Re: ***Jackson Water Supply Corporation - Docket No. 49269***

The purpose of this letter is to provide the first request for information from the Public Utility Commission of Texas. The information requested is below and addressed.

## Jackson WSC CCN

Request for Information: Staff 1-1

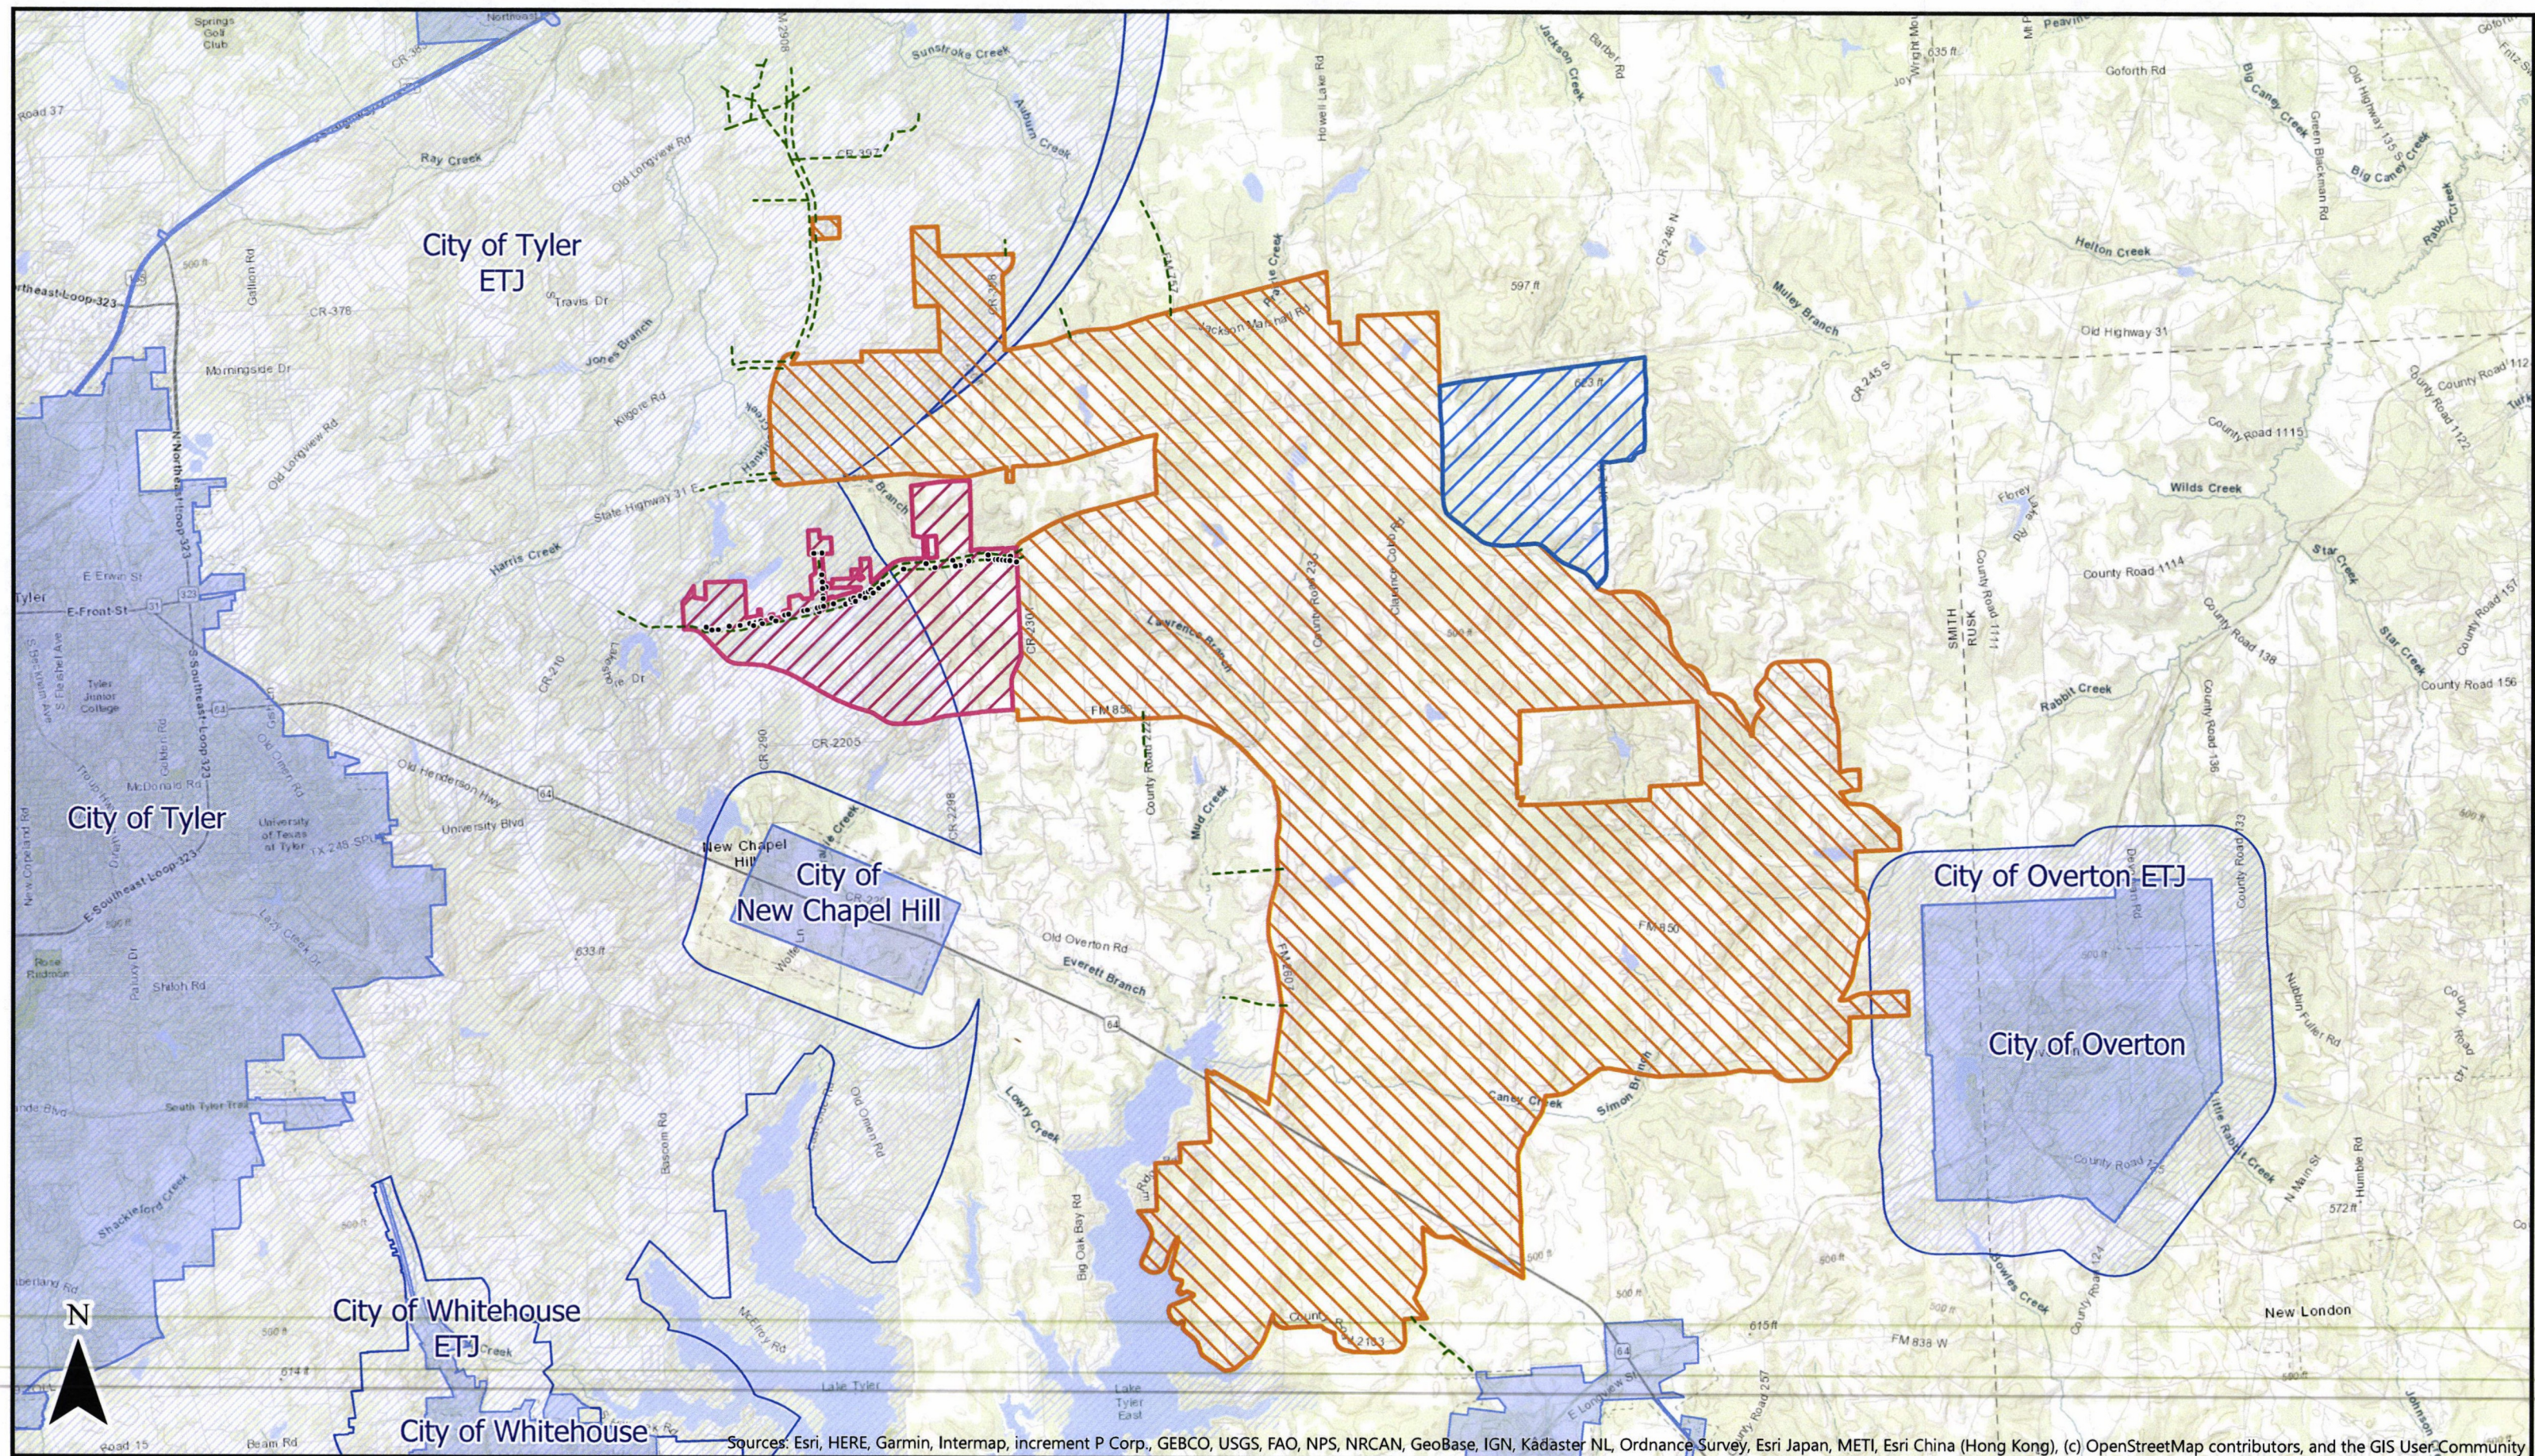
**Please provide a detailed map(s) identifying the location of all the following items:**

- a. **Boundary of Jackson WSC's existing water CCN No. 10763;**
- b. **Boundary of the requested areas in the current docket;**
- c. **Boundaries of city limits and extraterritorial jurisdiction;**
- d. **Potential customers requesting service within the requested areas; and**
- e. **Existing customers within the requested area.**

The map titled Jackson WSC CCN Request for Information: Staff 1-1 is attached.
